MEMORANDUM

CITY & BOROUGH OF JUNEAU

FILE NO.: USE2003-00046 - Allowable Use

PROPOSAL: An Allowable Use permit to allow a 5,760 square foot building for contractor storage.

SITE PLAN 1"=20'

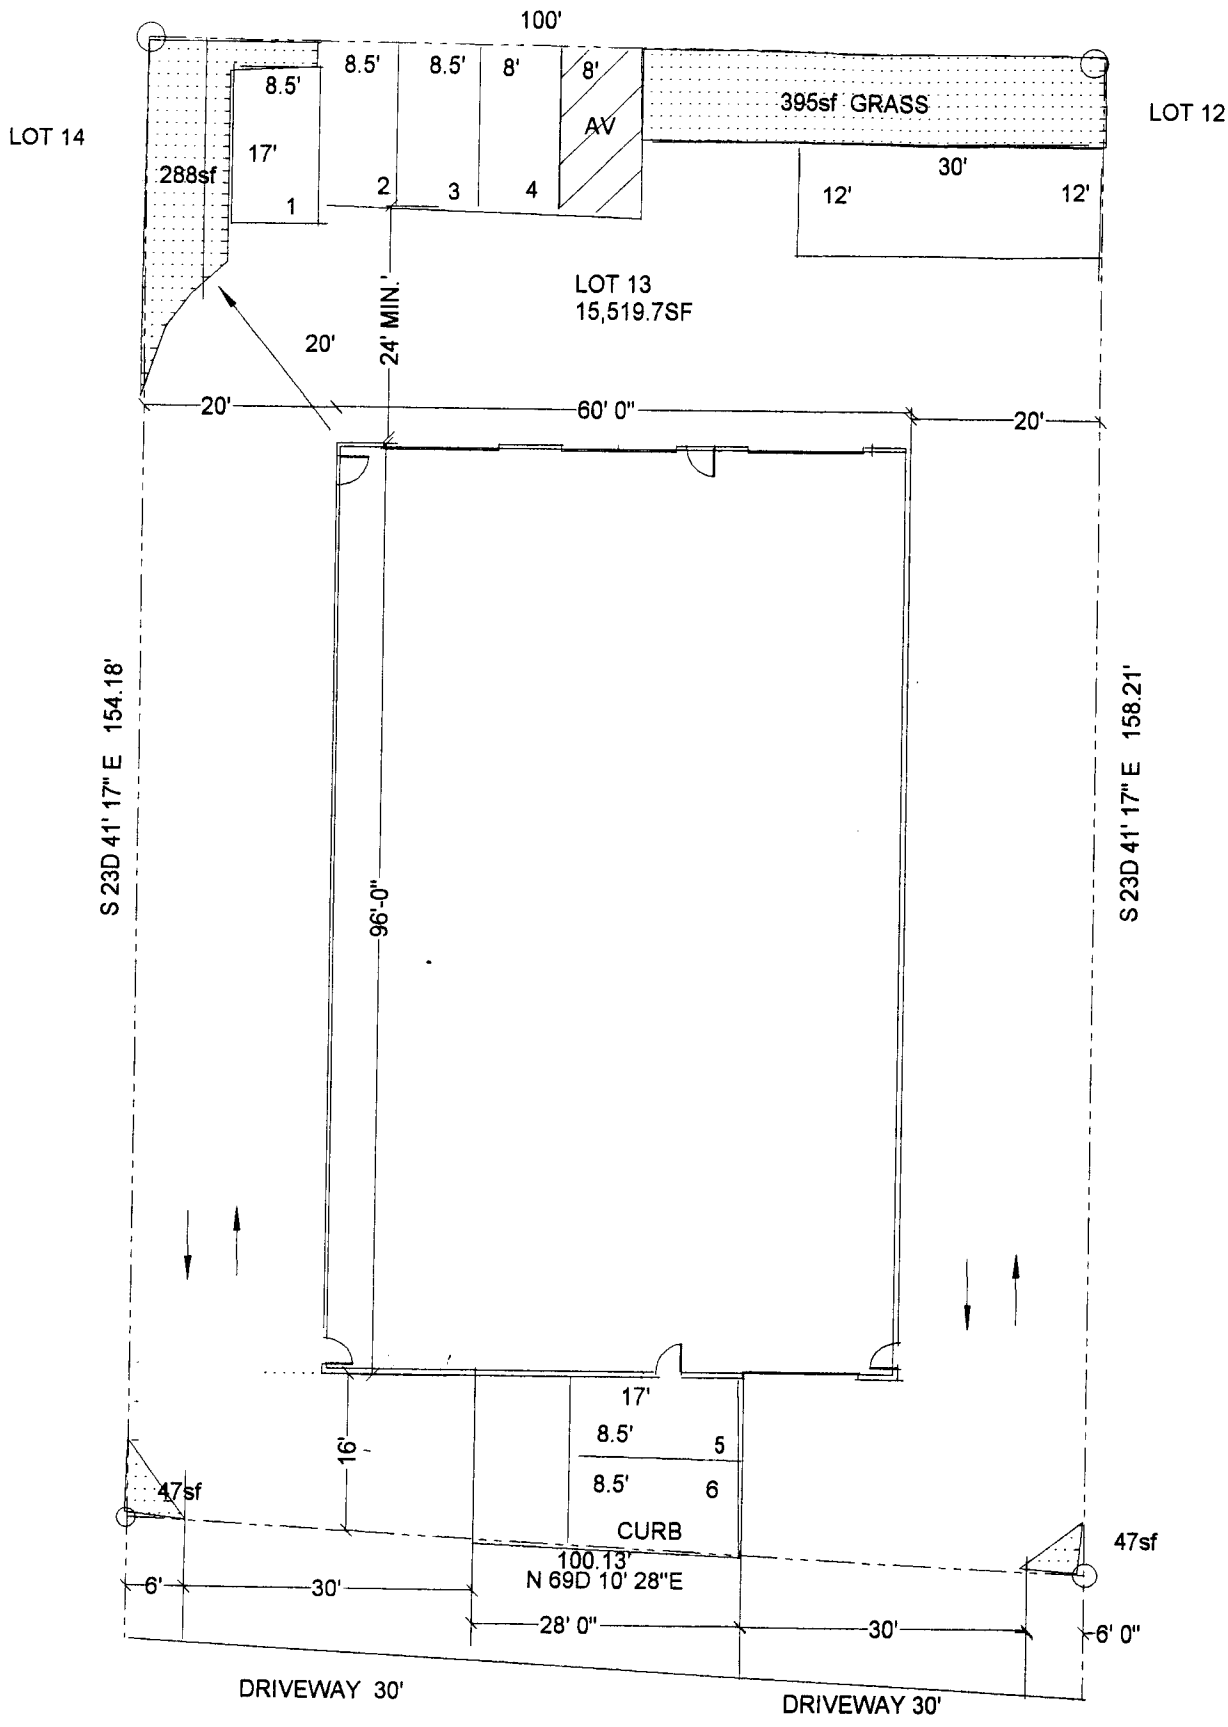
Project Design – The building is one story, with 5,760 square feet of storage accessed by six 12 foot by 14 foot cargo doors and six man doors (see Attachment A). A parking area will be to the rear of the lot, and two 30-foot driveways will allow two-way traffic into the site. Landscaping will be provided primarily along the rear of the lot, with two minor planting triangles at the front of the lot to help delineate driveway locations.

Parking and Circulation - Access is provided by two two-way access corridors onto the property and directs traffic to the rear of the lot where the majority of the parking is provided. This circulation pattern gets the traffic off Anka Street and onto the applicant's property in a suitable and safe manner. There is a loading zone and a van-accessible parking space at the rear of the lot. CBJ Engineering has stated that CBJ Streets regulates driveway widths and locations. Mike Scott, CBJ Streets Superintendent, has reviewed the applicant's revised site plan and does not see a conflict with the proposed design (see Attachment B).

Landscaping –The applicant proposes to have 782 square feet of vegetative cover at the rear and front of the lot to meet the 5% minimum vegetative cover requirement.

Yes. To address proximity to Lemon Creek and the need for increased permeability in order to prevent runoff into Lemon Creek, a condition of non-paving for the parking lot should be included as a condition of approval.

I don't see any problem with this. 30' is the commercial standard and this configuration will allow them room to back out on there driveway and pull out into traffic head first. They just need to make sure landscaping doesn't interfere with sight distances out of the driveways.

I recently processed an allowable use permit, however, i put a condition on the permit to not allow back-out parking onto anka street from the 3 bay doors which are in front of the building facing anka street. the planning commission and the applicant had a problem with the condition, and the applicant proposed an alternative solution of 2-30 foot driveways for access into and out of the property. could you look at these and see if they meet standards? anka, as you know, is a continuous valley drain, pretty flush with the street onto these properties. The site plan is attached, the building does not show the 3 bay doors on the front, but they are there (an architect "error").

1. Parking lot shall not be paved.
